LIST OF FIXTURES

COPY OF OWNER'S PLAN APPROVED

ADDITIONAL WORK

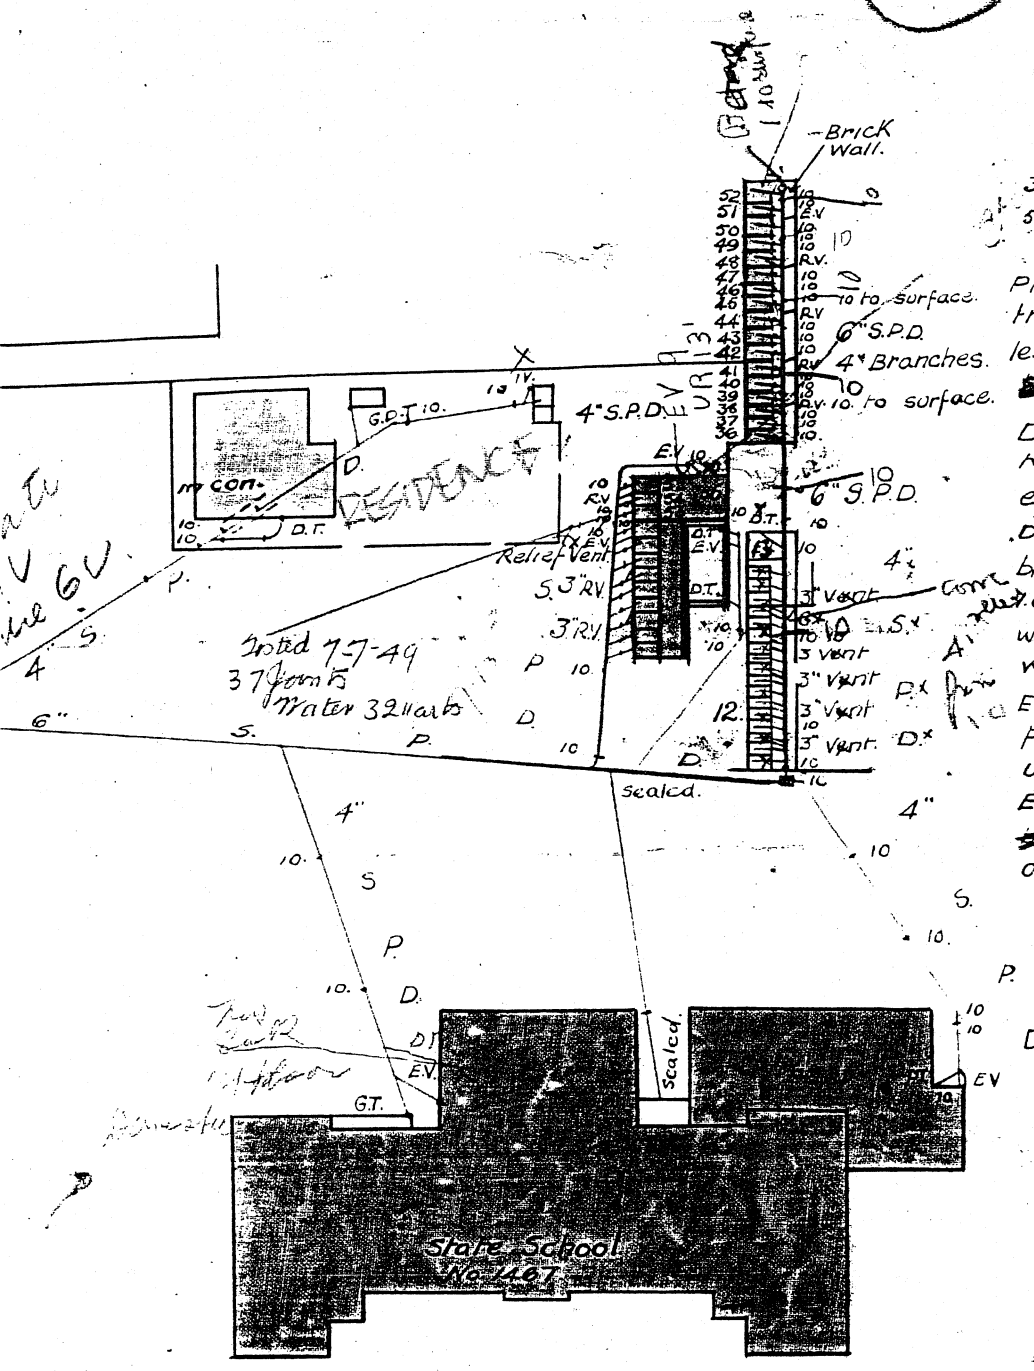
- 12 closets (17 No) to be abolished
- 13 urinal
- 36 to 52 closets proposed ext'l.
- 53, 54, 55. Closets
- 56 urinal
- Pipes under building near tree roots and those having less than 18" of cover are ~~to be~~ concreted.

Drains crossed in blue are ~~to be~~ cut & sealed at all ends & O.B's.
 Drains ~~to be~~ laid shown in blue.
 Drains to be brought to surface where indicated, & finished with approved covers.
 E.V. to be moved to new position & relief vent substituted.
 Existing drain from i.c. ~~to be~~ relaid to suit new group of closets.

Urinal — REPLACED WITH NEW.

(A) 1'-0" Main Drain altered
